STAFF REPORT
ITEM NO. Three.

DATE: *October 10, 2016*

COA REQUEST: *Guidelines Revisions*

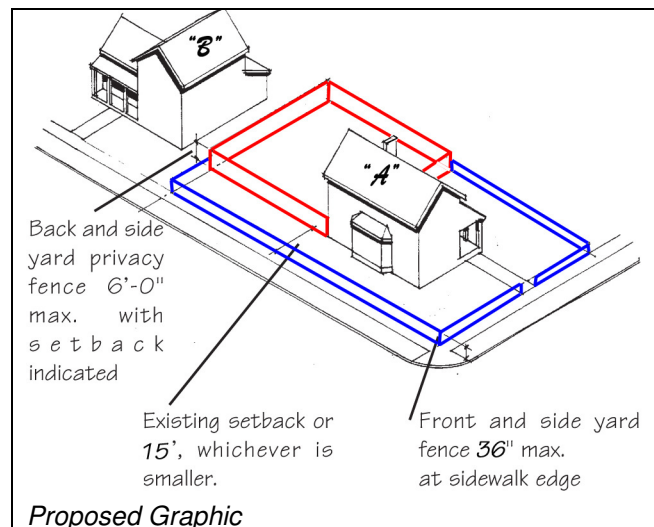
On page 61, there is text proposed to be changed on the height of fences.

When the backyard of a corner property "A" abuts the front yard of the adjacent property "B", and when property "A" installs a fence taller than 36" abutting the street, it may diminish the front yard of property "B". The zoning ordinance states that between a required building setback line and a street right-of-way, the maximum height shall be lower than other fences in the rear yard. The zoning ordinance would require the street facing privacy fence (greater than 4' tall) to be set back the distance of the side yard setback of 10% of the lot or 5 feet. Those five feet may differ from the actual setback of the primary structure. The HDC may be stricter than the zoning code, but cannot be less strict without the project having a public hearing with the Planning Commission or the Board of Adjustment.

Fences in side and rear yards with street frontages should not impede views of adjacent houses that have a different orientation. For those fences, the location of the fences that are in excess of 36", as shown in red, should be the wall of the primary building or 15', whichever is less.
